Subject: Response to Comments
Air Science Consultants, Inc. Letter to Peters Township Planning
Commission dated March 2011
CEC Project 101-462.0001

The purpose of this letter to respond to comments made by Dr. Stanley L. Penkala in his "Evaluation of Funeral Home with Crematory Variance Request" dated March 2011. That document includes a "Critique of Air Quality Evaluation Report [CEC Report]" which offers several comments relative to CEC's September 2, 2010 Air Quality Evaluation and February 24, 2011 addendum. Dr. Penkala's comments and CEC's responses are itemized below.

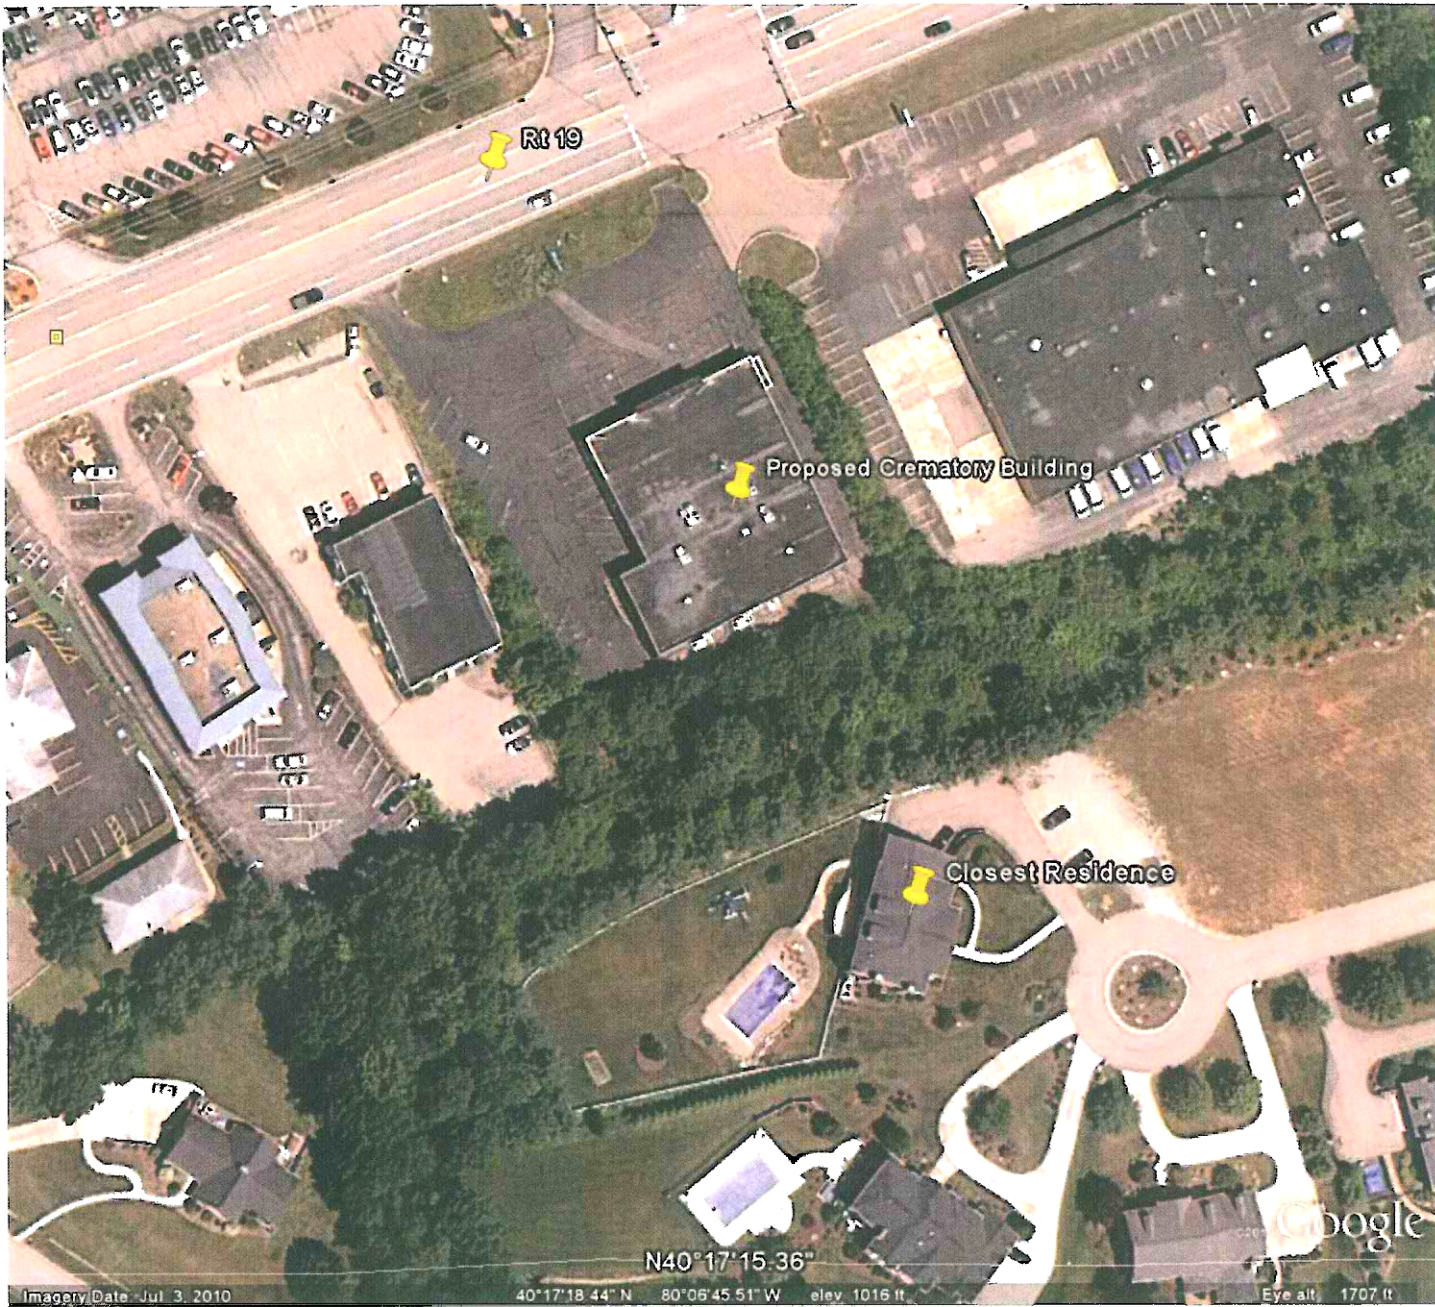
Comment 9. “In modeling this facility, the concentration estimation should have started at the nearest distance to a property line, in whatever direction that might be, and significant receptors (e.g., nearest commercial building, nearest residence) should have also been input.” (Page 8, Paragraph 3).

Response 9. CEC agrees that actual receptor locations and elevations should be considered in a screening evaluation. CEC agrees with Dr. Penkala that the closest receptor is the residence located on the cul de sac of Sussex Way (see enclosed Google Earth image). CEC has estimated the ground elevation of that property to be approximately 1,050 feet. The estimated base elevation of the crematory property is about 1,015 feet which puts the closest receptor about 11 meters above the stack base. Therefore, assuming a 26-foot building and 3-foot stack (total elevation of 1,044 feet), the closest receptor will be about 6 feet above the stack height.
